## City of Sedona Public Works Department

The City of Sedona, Arizona is issuing **Addendum #2** to the plans and specifications as originally issued at the time of solicitation for bids for the **Chapel Road Shared Use Path Improvements Project**. For any bid to be considered responsible and responsive, receipt of this addendum must be acknowledged.

**City of Sedona – CHAPEL ROAD SHARED USE PATH IMPROVEMENTS PROJECT**  
**Project # 2022-SIM-11h**

EXHIBIT  
NO.3

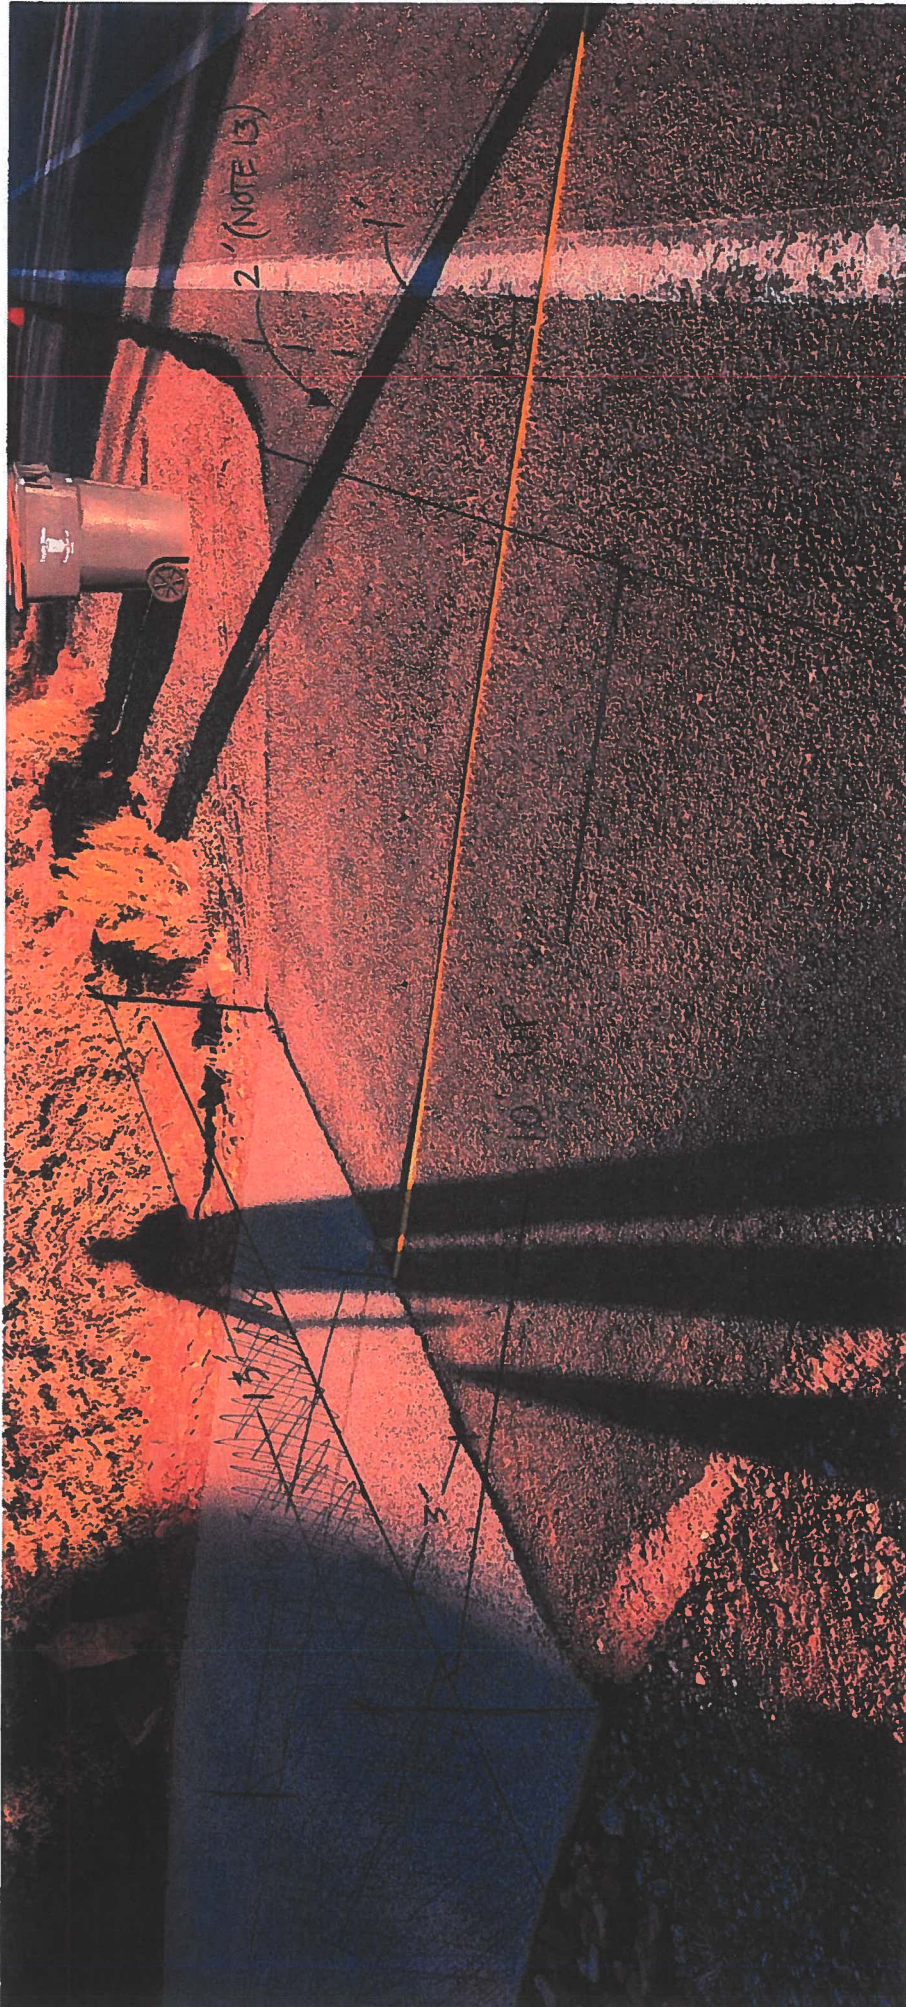
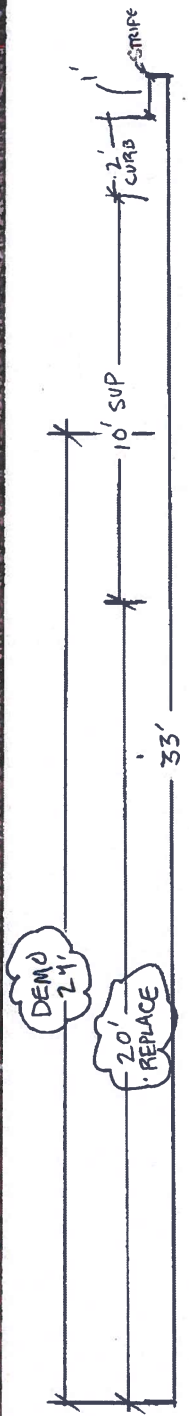
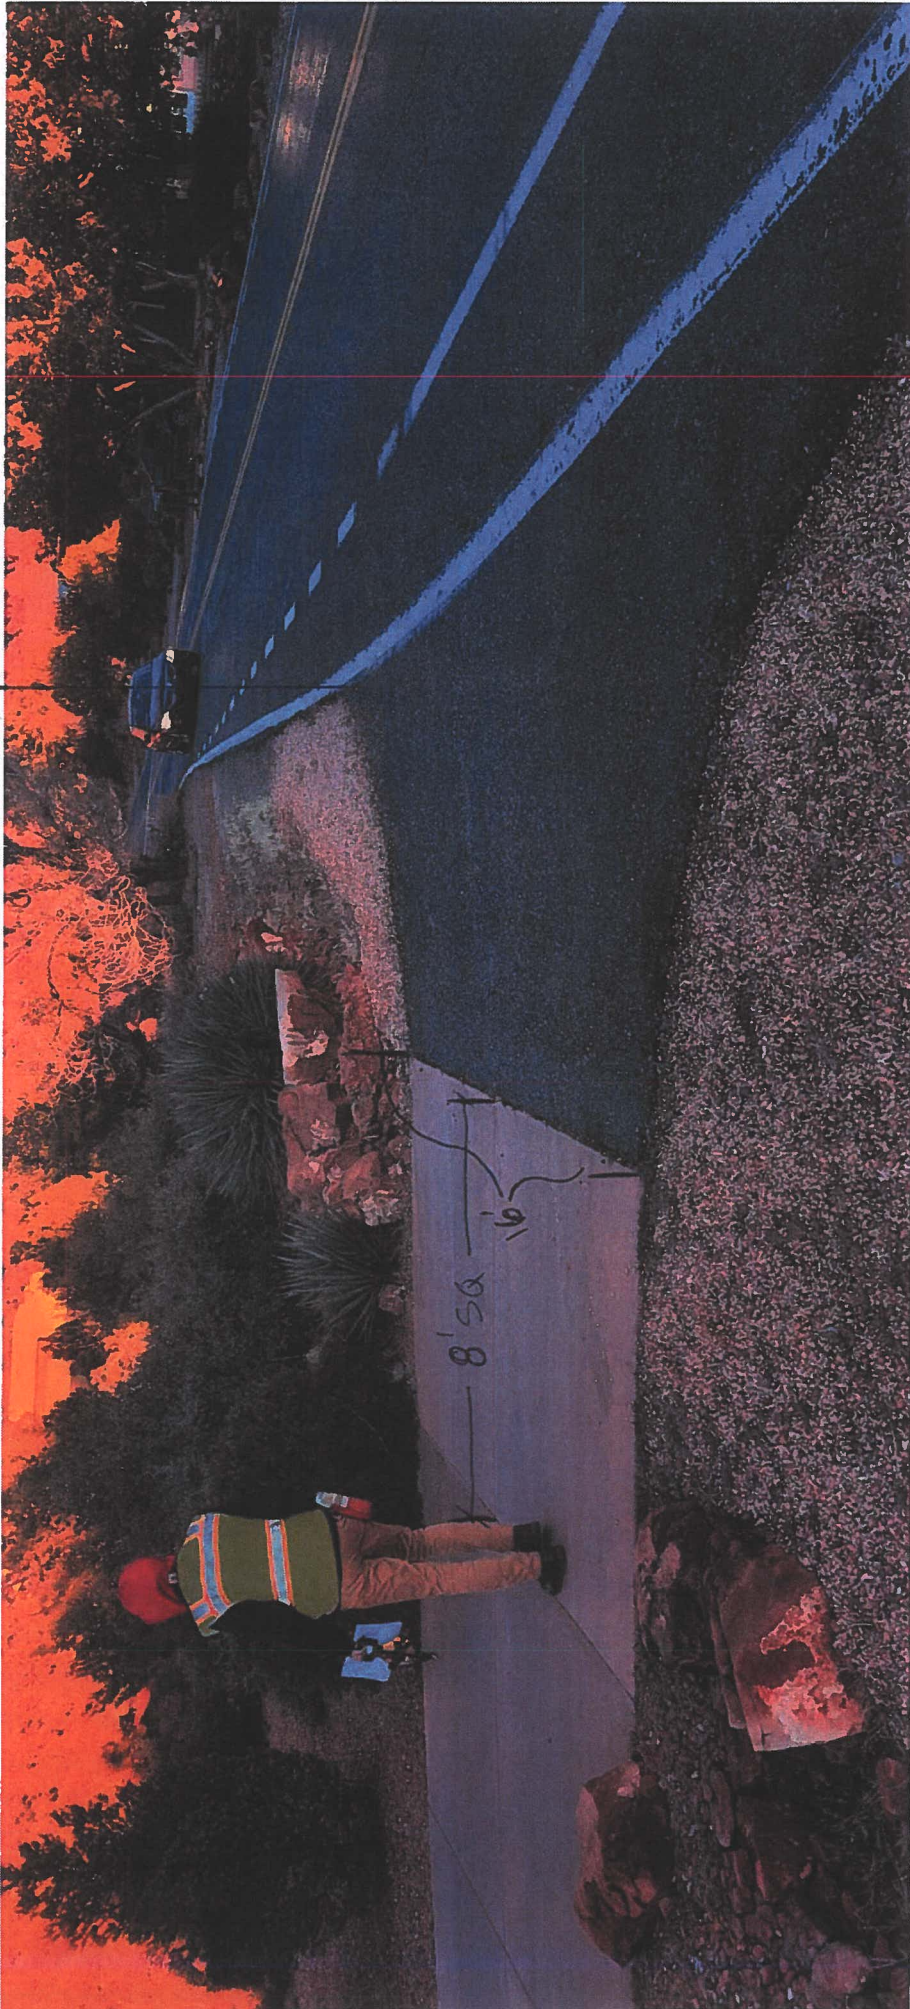
STA 4+25 LOT 40  
GRAY EXP. AGGREGATE

REMOVE = 8.6 SQ YDS.

REPLACE = 4.5 SQ YDS.

2. Bid Item #25 reads "5-INCH CLASS A CONCRETE REPLACE DRIVEWAY MAG SP340 2 LS"  
*Driveway replacements are listed as lump sum. There are 2 concrete driveways that will need to be cut, remove existing concrete (bid item #17), place AB to new grade to match SUP trail, form and pour concrete and finish similar to existing drive (i.e. one driveway is grey exposed aggregate (page 6) and another is Sedona Red (page 7)).*

**EXHIBIT NO. 5  
LOT 35 PAVER  
DRIVEWAY**

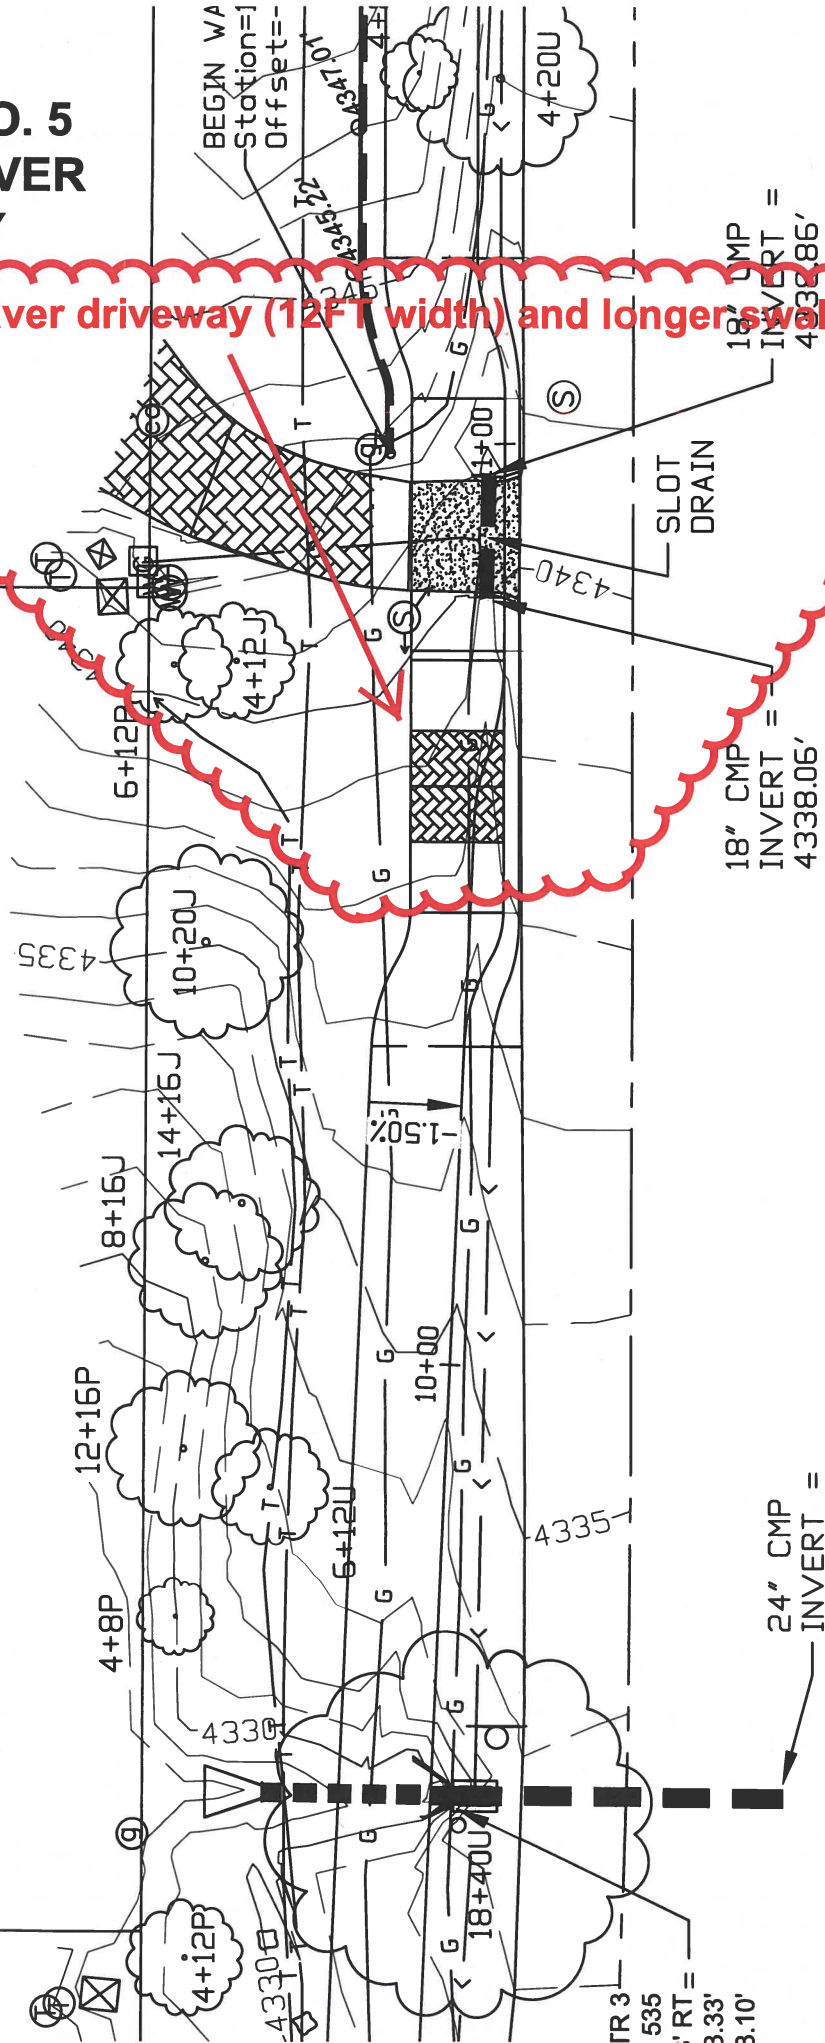
**Additional paver driveway (12FT width) and longer swale area**

7. There are not pavers proposed at Lot 26 driveway alignment at this time.  
*Correct*
8. Driveway at Lot 27 -  
*Grading is anticipated to be within the Right-of-way.*
9. Driveway pavers at Lot 35 -  
*See page 8, Exhibit 5, of this addendum regarding the addition of the pavers for this driveway. Bid Item #26 is updated.*
10. Driveway at Lot 37 -  
*Temporary Construction Easement in process.*
11. Detail for culvert through headwall at Sta 24+00 -  
*See page 9, Exhibit 6, of this addendum which is a draft detail of the pipe penetration. The final detail will be signed and sealed by the structural engineer who prepared this detail.*
12. Replace Road Edge Striping -  
*Not included in scope of this project.*
13. Dry Stack Wall on Plan Sheet 4 & 5 do not have start and stop Stations identified  
*Anticipated linear footage is included as Bid Item #35.*

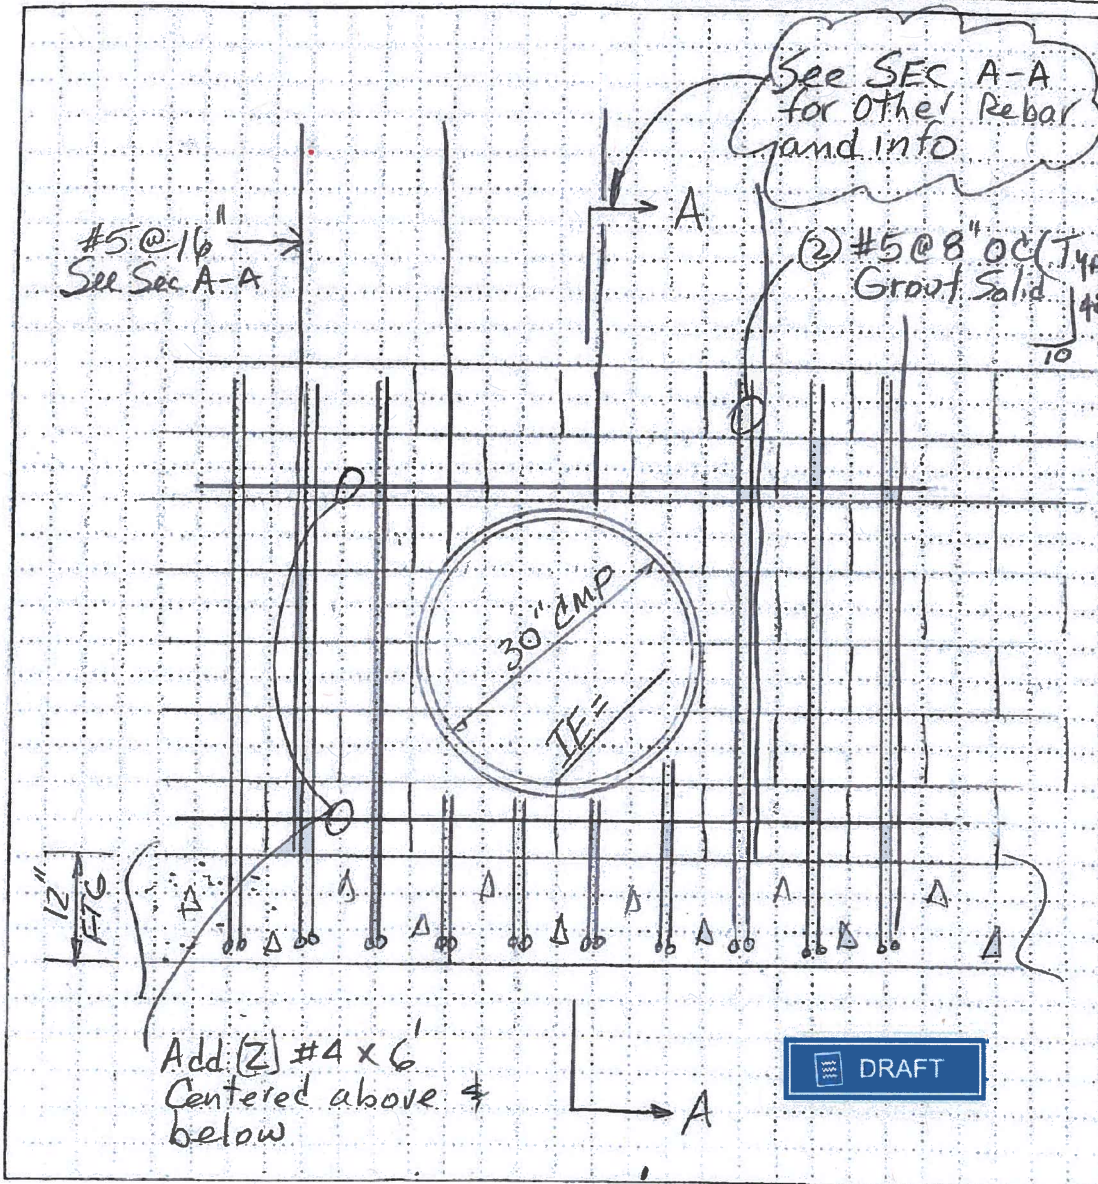
1. Exhibit No. 1-  
Page 4 of 9, corner of Geneva and Chapel Road Monument boulder location.
2. Exhibit No. 2-  
Page 5 of 9, Temporary Construction Easement and landscape boulder location on Lot 37.
3. Exhibit No. 3-  
Page 6 of 9, Lot 40 existing driveway remove and replace.
4. Exhibit No. 4-  
Page 7 of 9, Lot 37 existing driveway remove and replace.
5. Exhibit No. 5-  
Page 8 of 9, Additional Paver Driveway at Lot 35.
6. Exhibit No. 6-  
Page 9 of 9, Engineering Draft for Note 45, pipe penetration of retaining wall.
